Service Bulletin

Bulletin No.: 24-NA-148

Subject: **Transmission Slip, Harsh 3-4 Shift or Harsh 5-6 Shift, Delayed Shifts, Delayed Shift into Reverse, Harsh Shift into Reverse, Slips in Reverse or No Reverse, Malfunction Indicator Lamp (MIL) Illuminated - DTC P2714 and/or P2732 Set**

Attention: **This TSB only applies to the 10L1000 RPO (MKM) with the 6.6 (L8T) gas engine. This does not apply to 10L1000 (MGM) (MGU) with 6.6 (L5P) diesel engine.**

6712755

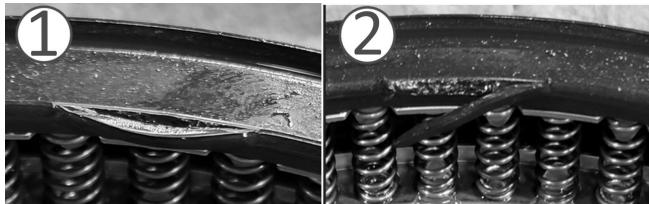
- A good seal will have an orange stripe.

- A degraded seal will be all black.

Correction	<p>Note: Inspection of the transmission oil pan in many cases, will show no or minimal clutch sediment present. Replacement of the valve body does not resolve the condition. Replace the Triple Clutch Housing (518), 1-2-3-4-6-7-8-10-Reverse Clutch (C4) Apply Piston (523), C4 Apply Piston Outer Seal (525) and the 4-5-6-7-8-9-10-Reverse Clutch (C6) Apply Piston (534).</p>
-------------------	--
